ZANCOR  
HOMES

## PURCHASER REQUEST FOR EXTRAS

Royal Collection

| Lot No. | House Type | Elevation | Date Required | Date Ordered |
|---------|------------|-----------|---------------|--------------|
| 53      | Windsor    | A         |               |              |

GROUND FLOOR  
ELEVATION A

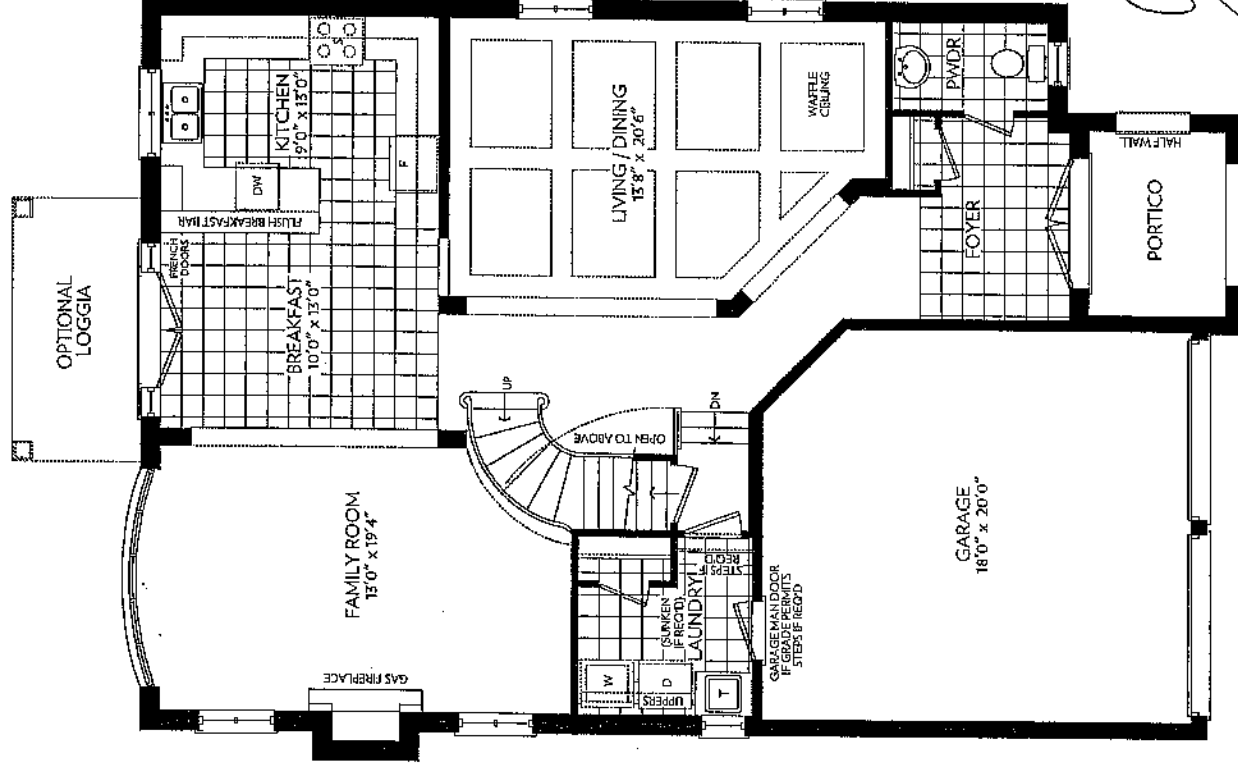
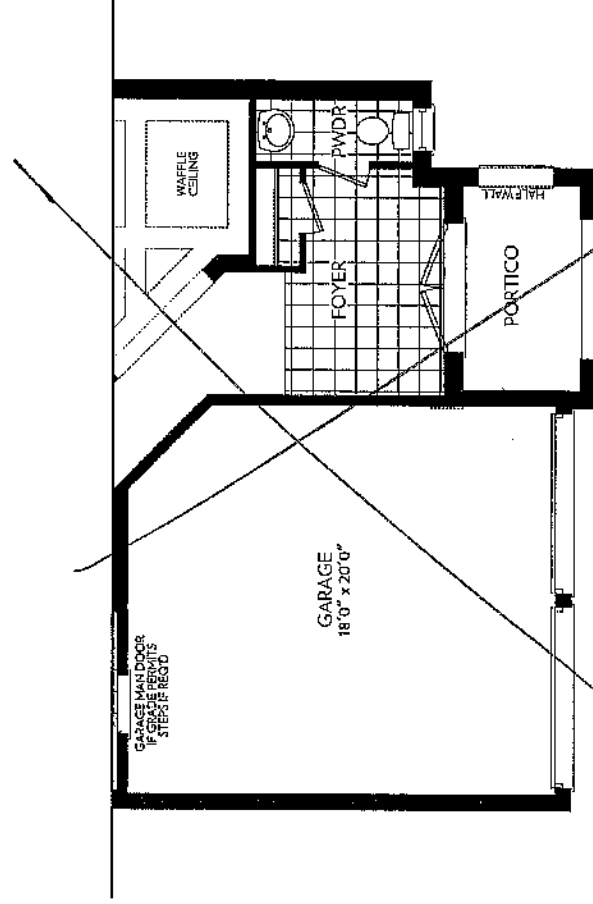
| "OFFICE USE ONLY" | ITEM | DESCRIPTION                                                                                                                                                                                                              | PRICE |
|-------------------|------|--------------------------------------------------------------------------------------------------------------------------------------------------------------------------------------------------------------------------|-------|
|                   | (12) | Slider Door Entry into<br>Laundry Room grille<br>permitted & Town approval.<br>Remove Window & put<br>door into laundry<br>room. Remove cabinet<br>in laundry room.<br>If deck needed<br>Purchaser to pay at<br>closing. |       |
|                   | (13) | Change location of<br>Washer/Dryer/Tub<br>room to accommodate<br>side door<br>Entry.<br>Paid by Cheque                                                                                                                   |       |

SECOND FLOOR  
ELEVATION A

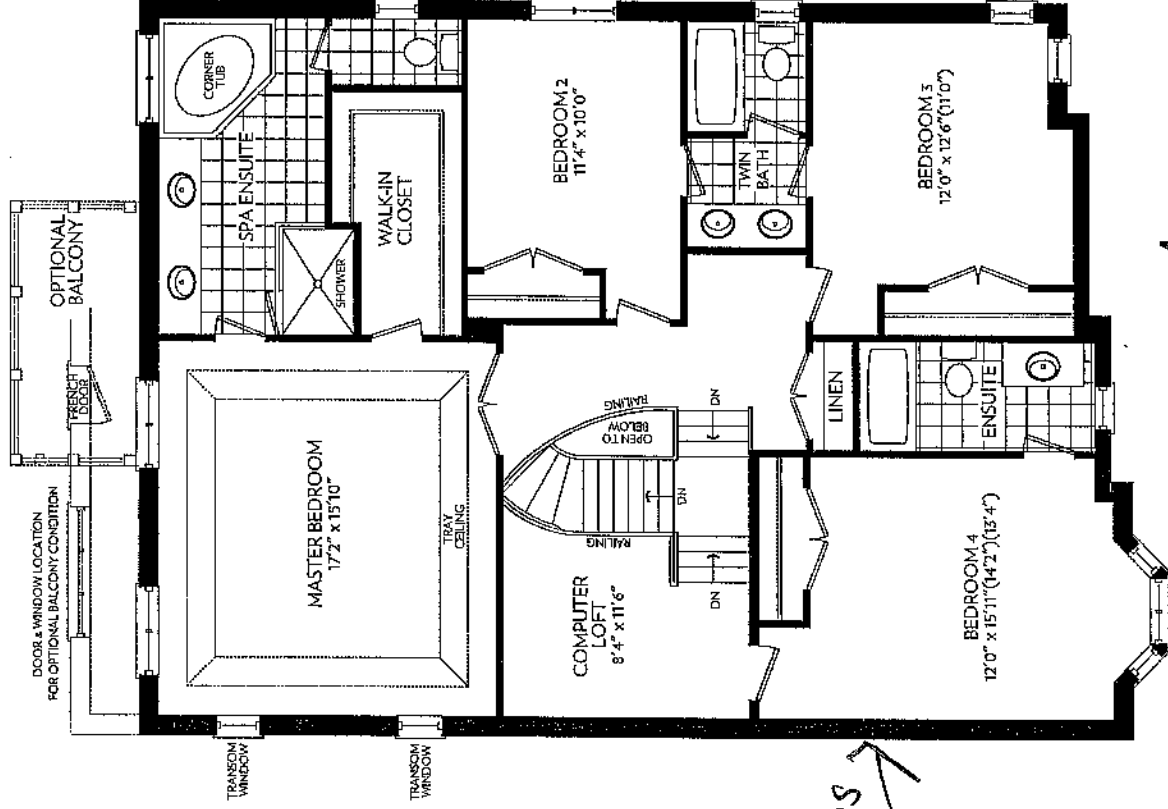
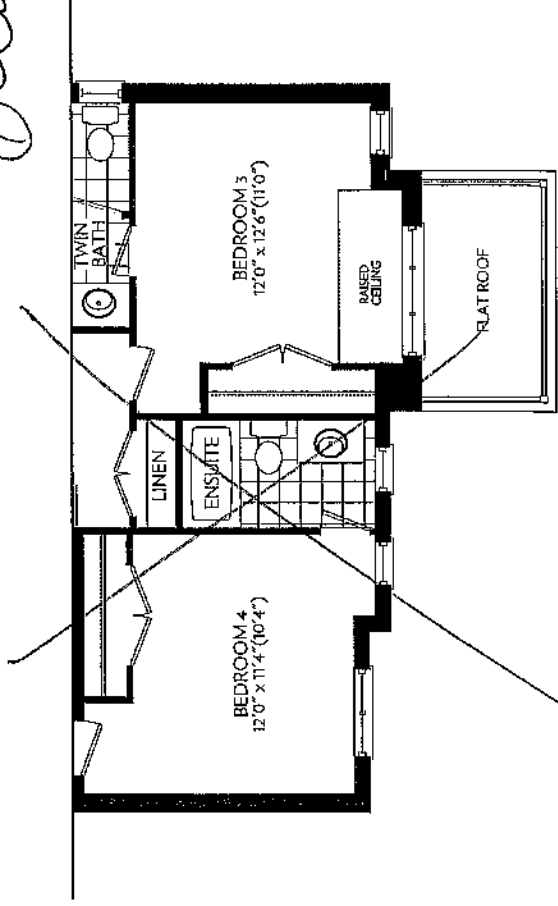
19 ALL  
DOORS TO  
2ND FLOOR  
7 FT. HIGH  
HOLLOW DOORS
